PLANNING, ARCHITECTURE, ZONING BOARD

November 17, 2025, 6:00 p.m.

City of Avondale Estates
Planning Architectural Zoning Board
Staff Review, Variances *

Applicant: 278 Oak Holdings LLC: Jetha Wagner, Avila Development

Figure 3.2.12.F - Transitional Height Plane

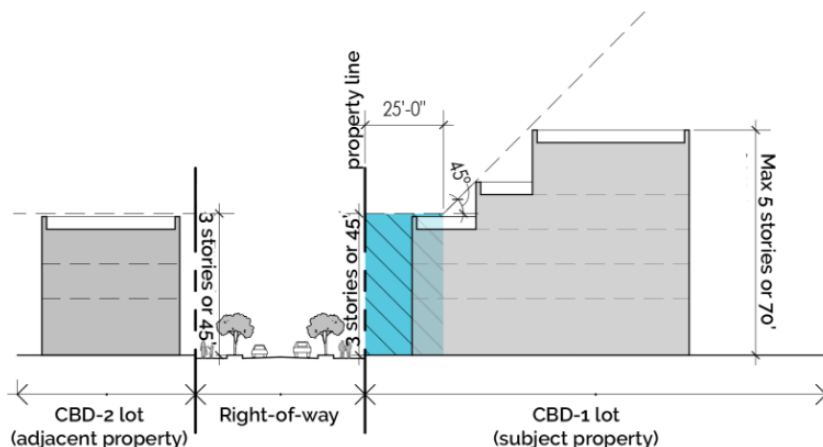
DESIGN TEAM NOTE: This requirement impacts the Southeastern corner of the Maple Street site, which abuts the CBD-2 district across Olive Street. This would limit that portion of the building to 3-stories (instead of 5) which could eventually step up to 5-stories. See Figure 3.2.12.F below. Need to be allowed 5-stories (plus basement) in all locations – including areas where transitional height plan comes into play.

Figure 3.2.12.F - Transitional Height Plane

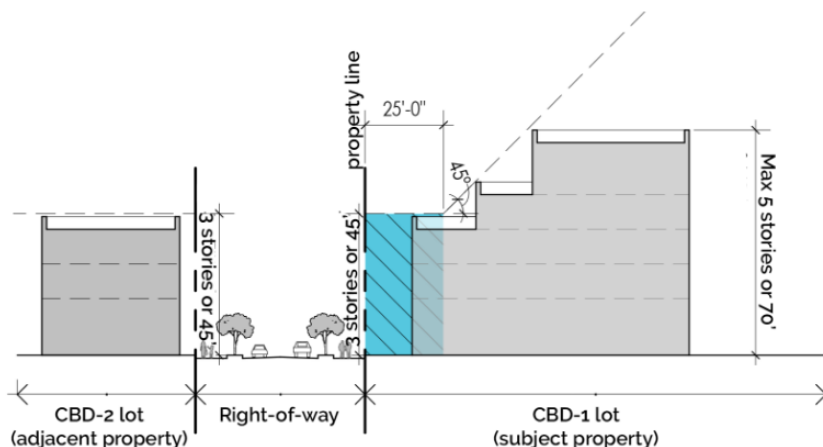
DESIGN TEAM NOTE: This requirement impacts the Southeastern corner of the Maple Street site, which abuts the CBD-2 district across Olive Street. This would limit that portion of the building to 3-stories (instead of 5) which could eventually step up to 5-stories. See Figure 3.2.12.F below. Need to be allowed 5-stories (plus basement) in all locations – including areas where transitional height plan comes into play.
